SERVICE NOTE NO. 002-2007

TOPIC: RECALL CAMPAIGN

SUBJECT: Update of fuel pump for Griso 850, Griso 1100

3. CHANGE THE RUBBER HOSE

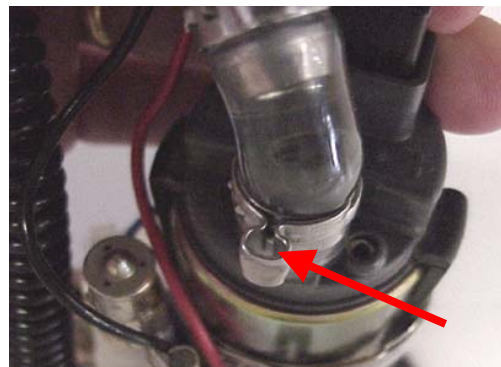
First of all remove the 2 metal clamps that retain the hose.

You can use tongs, positioning them on the side of clamp eye, to cut it away; as shown, cut should be on the side, in the eye.

5. CORRECT CLAMPS POSITION

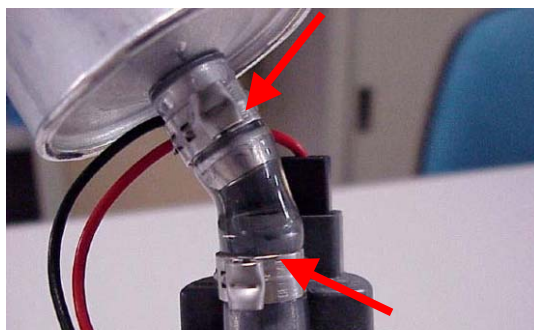
After removing the clamps and the rubber hose, install the kit consisting of 2 clamps and one section of clear tube, as shown on the side.

- Take the clear tube and start fitting it in from pump end.
- Fit the two clamps.
- Fit the other end of the tube on filter.
- Tighten the clamp, using tongs and closing the "clamp's eye" so that the two side bands nearly touch one another (see figure).

- The clamp on pump tube should be located close to the pointed end on the delivery tube.
- The clamp on filter tube should be located close to the pointed end on the fuel filter.
